## DESCRIPTION OF DIFFERENCES

between ORIGINAL and SIMILARITY

SIMILARITY Model No.: KX-TG7641 (Base Unit)  
 Name of Appliance : 1.9GHz Cordless Telephone System/2.4GHz Bluetooth Transmitter  
 FCC ID : ACJ96NKX-TG7641

ORIGINAL Model No. : KX-TG6581 (Base Unit)  
 Name of Appliance : 1.9GHz Cordless Telephone System/2.4GHz Bluetooth Transmitter  
 FCC ID : ACJ96NKX-TG6581  
 Approval Date : Feb. 18, 2010

<b>ORIGINAL</b> KX-TG6581	<b>SIMILAR</b> KX-TG7641
<b>RF Type and Appearance</b>	1.9GHz US-DECT & 2.4GHz Bluetooth  	1.9GHz US-DECT & 2.4GHz Bluetooth  
<b>P.C.B. of Base Unit</b>

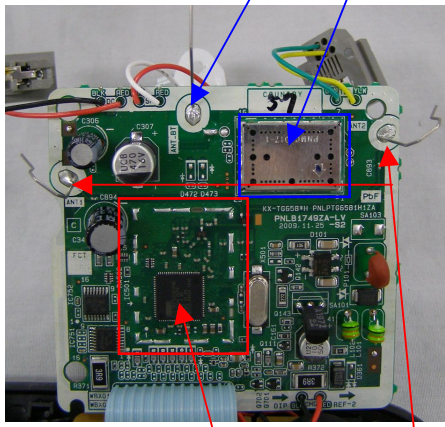
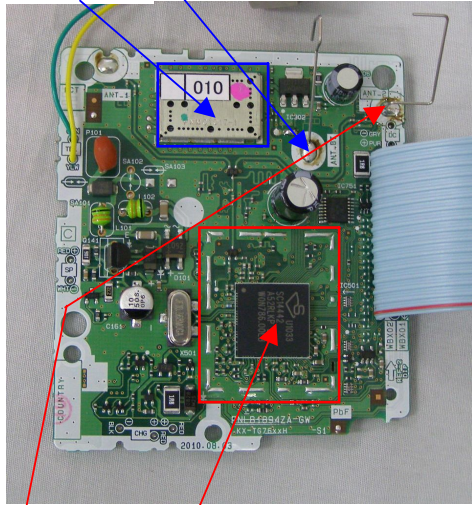
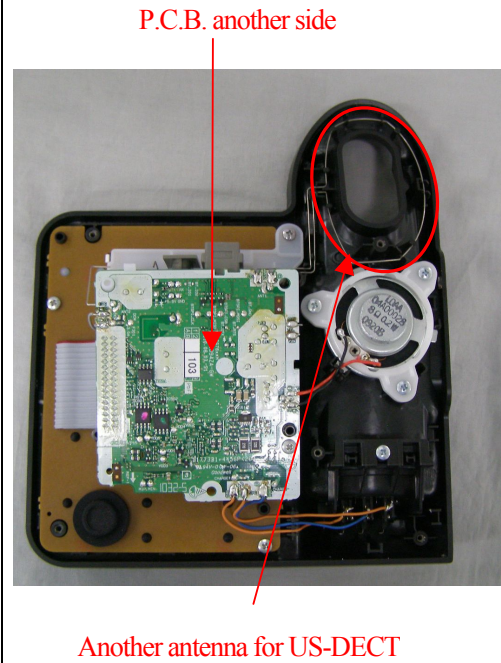
Antenna for Bluetooth is different.  
 Bluetooth RF Block is same.

Antennas for US-DECT are different.  
 US-DECT RF Block is different

NOTE: The 2.4 GHz Bluetooth RF Block of KX-TG7641 is identical to that of KX-TG6581.
